5TH AND VIRGINIA

Proposed MUP #3018037

# SECTION 02. RESPONSE TO EDG

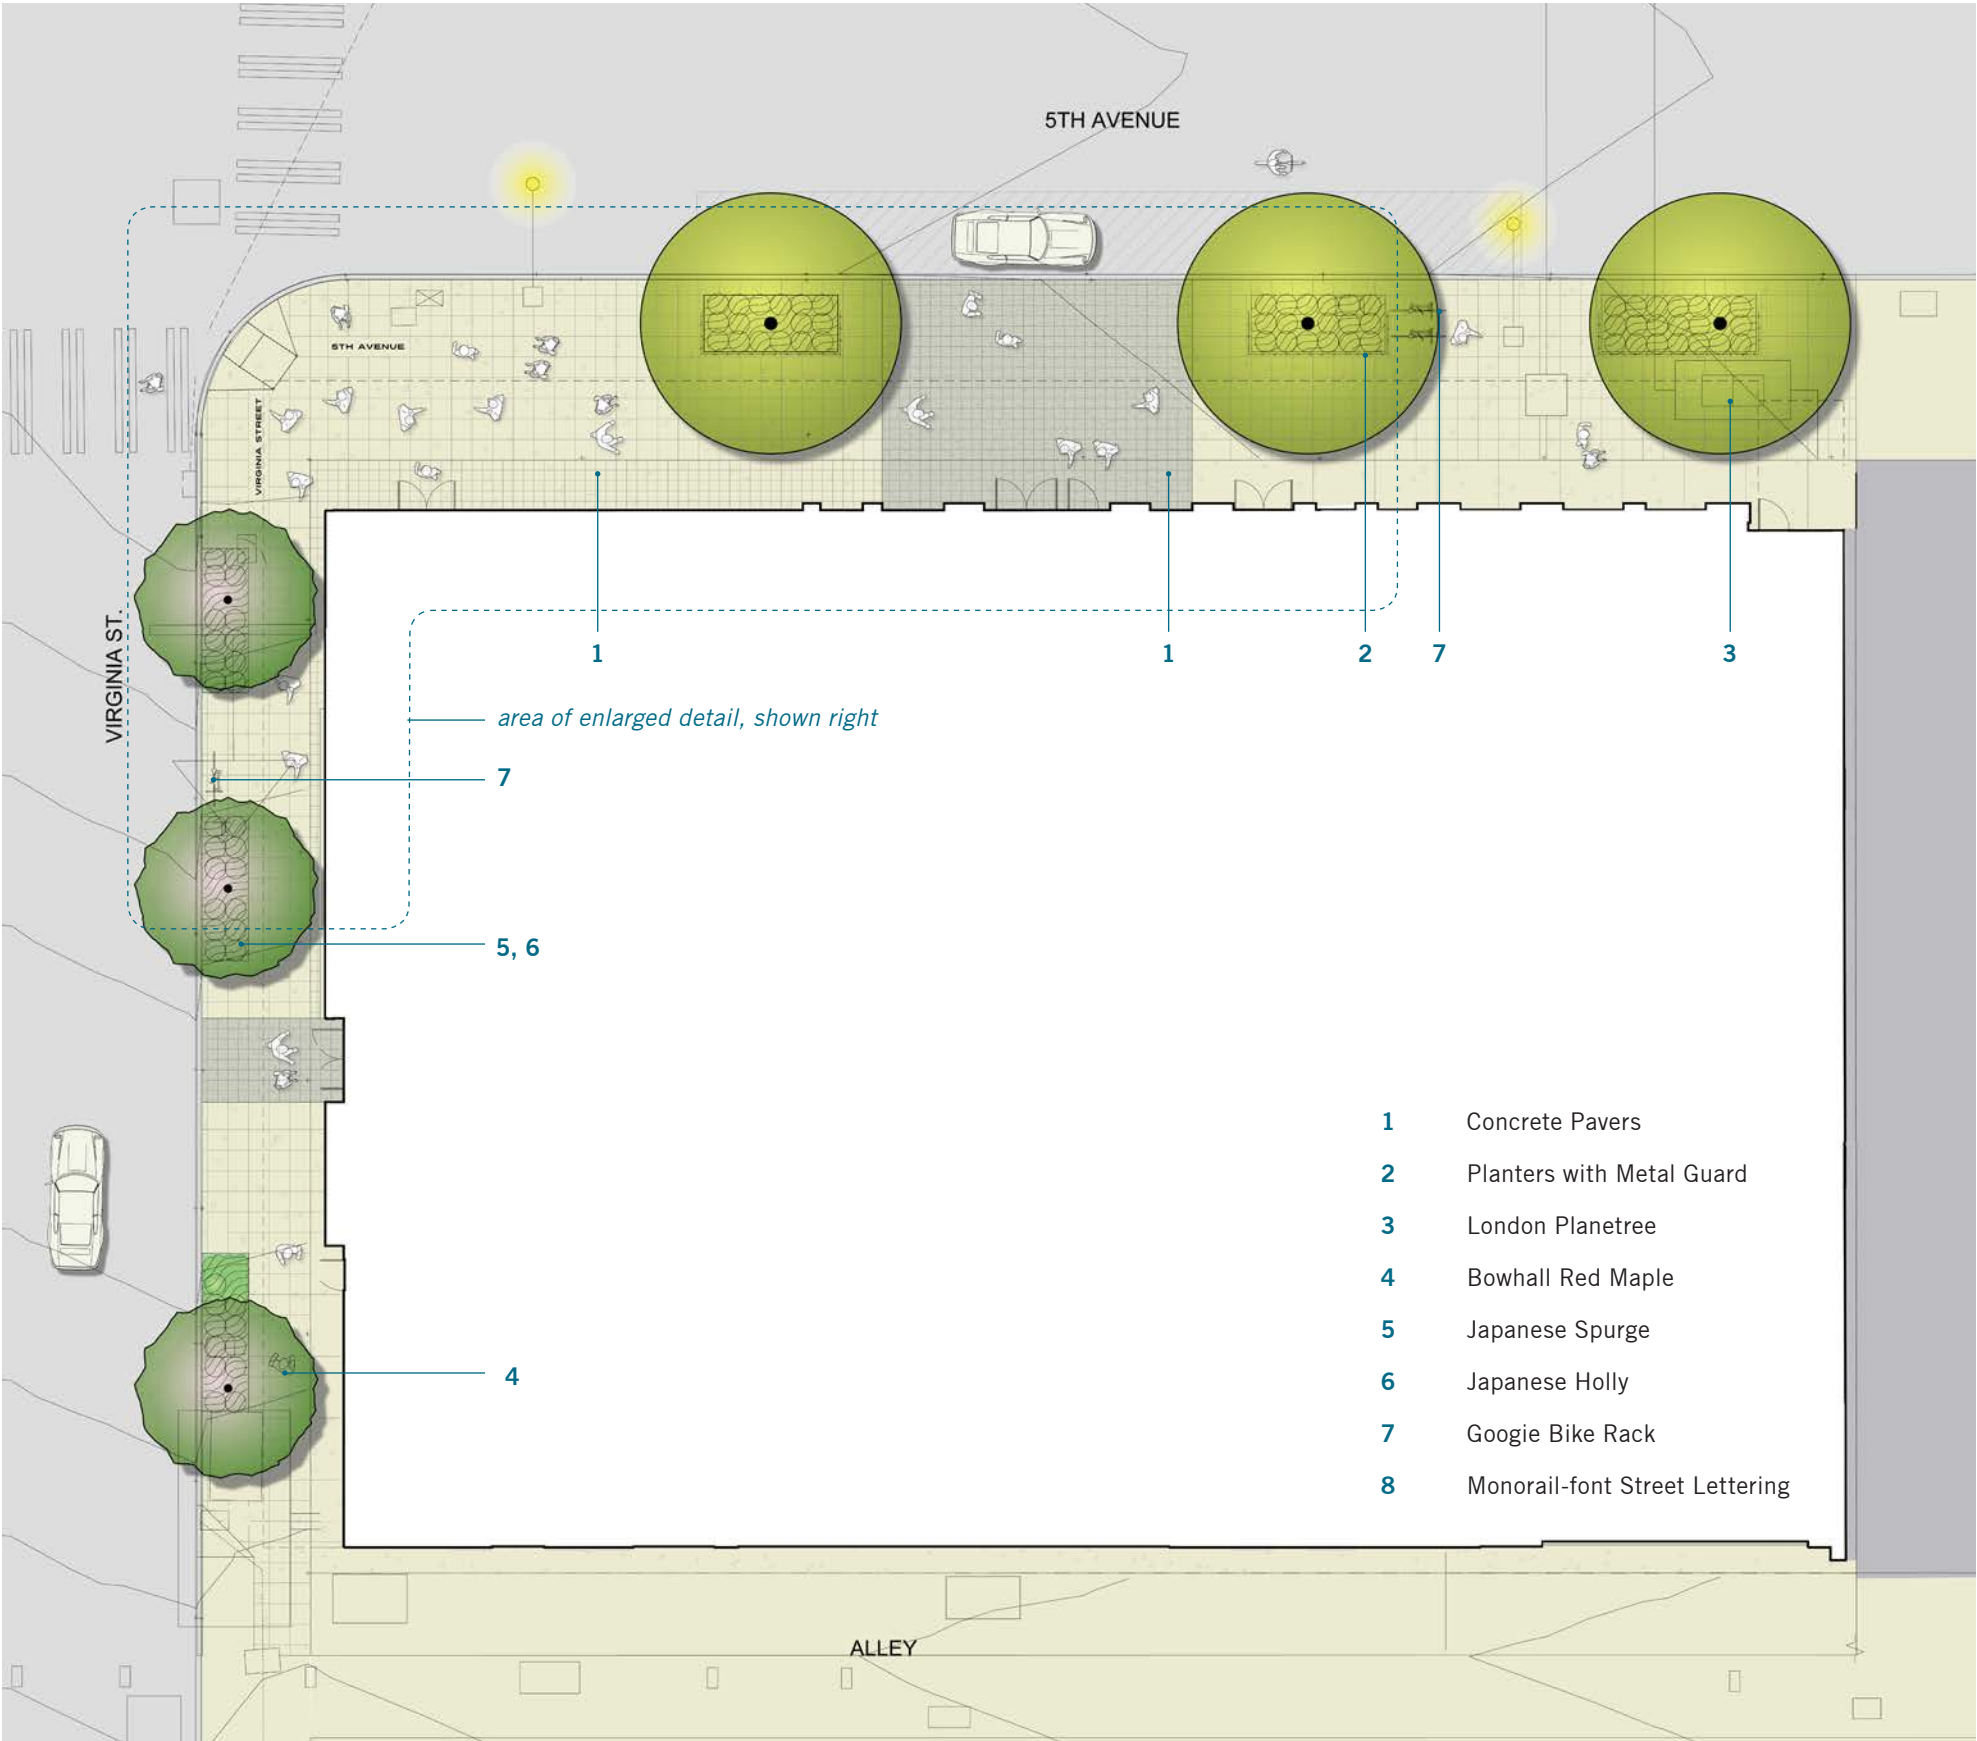
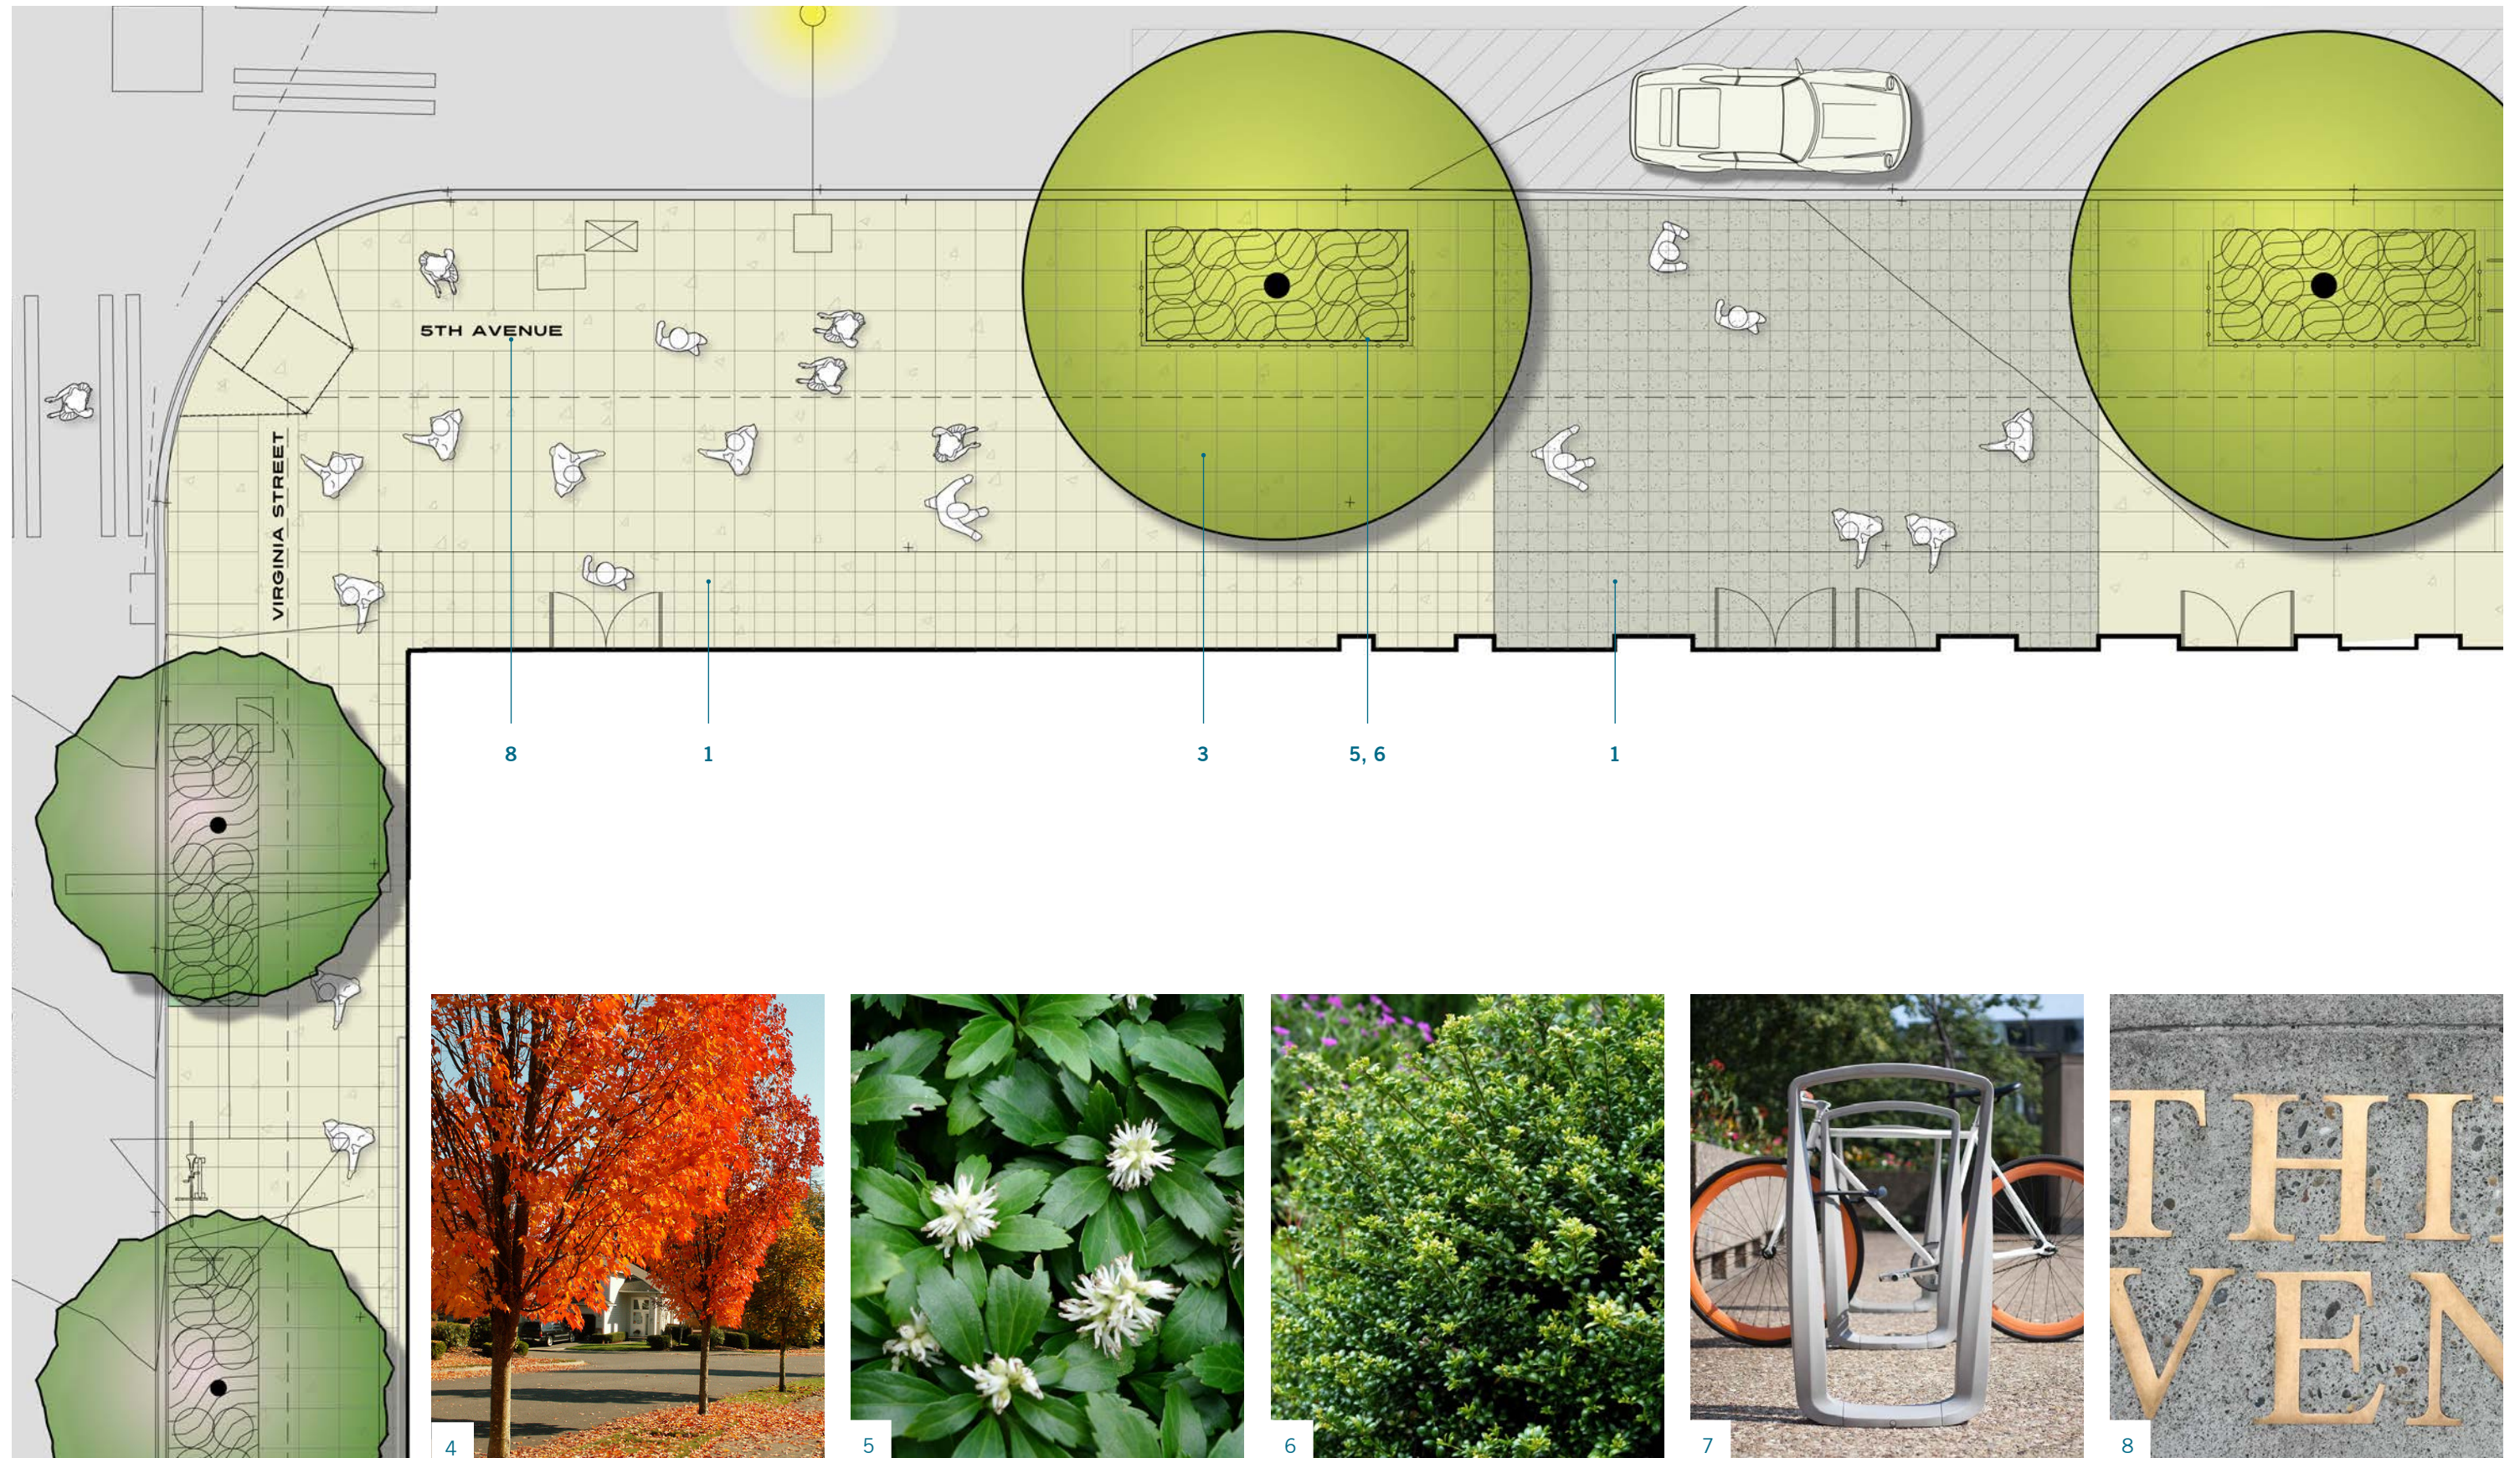
The sidewalk paving and landscape design shown on page 35, appears to be downtown standard, other than one ‘googie style bike rack’ in deference to the monorail and Belltown Guideline D3.III.f. The Board supported a more complete exploration of streetscape, tree planters, lighting, signage and design elements that define place and reference the Belltown Neighborhood, the art and heritage of this specific site, and a generally more robust response to several guidelines that stipulate more than the generic, minimal streetscape shown. (D2.I, D3.I, D3.III)

A purposeful and restrained design approach to the public realm has been proposed and is detailed to achieve an “uncluttered” and engaging connection to street level uses via widened sidewalks, specialty paving, plantings, street trees, bronze street name sidewalk inlays at the corner, lighting, signage, “googie” bicycle racks, and “googie” tree guards.

The proposed design reinforces indoor/outdoor uses without creating barriers and is consistent with DRB support of the ground level engagement of the building. The expanse of paving at the corner of 5th Ave and Virginia provides for a future outdoor sidewalk café outside the operable Nanawall type doors, while maintaining sufficient sidewalk space in this area to foster the greater pedestrian traffic on this part of the site. Street tree locations have been coordinated with SDOT, King County Metro, Seattle Monorail Services, and other utilities requiring overhead clearances. Planter locations have been increased to the extent possible with King County Metro uses along Virginia, and a potential Valet Loading Zone along 5th Ave. Shorter planters are more appropriate in high pedestrian traffic areas, and all paving proposed is non-standard specialty scoring (SDOT acceptable) with a unique concrete mix proposed at the entrances.
